Denial of a Certificate of Appropriateness – 1410 W. Linden Street

**Historical Architectural Review Board
COA Final Review Sheet**

HDC-2022-00058

Proposal: Legalize porch replacement (Violation Correction)

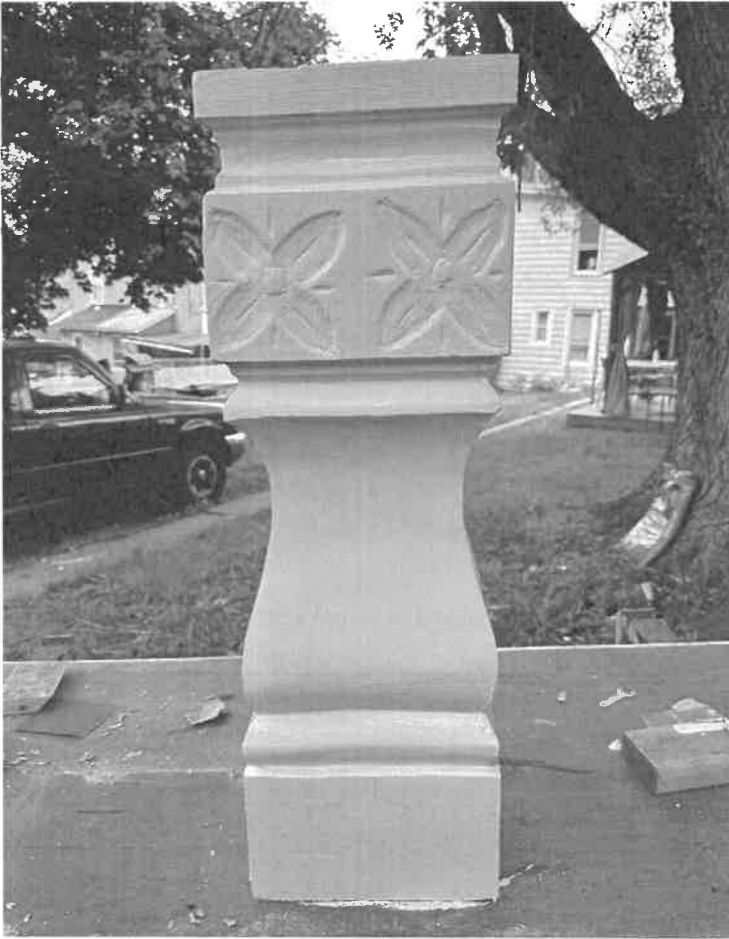
The applicant proposes to install wood balusters that are similar to, though not an exact match of, the original. According to the drawing, the top and bottom rail would be less substantial than the original. Staff suggests finding a railing that more closely replicates the original size and profile and asks the HARB to comment on the proposed balusters.
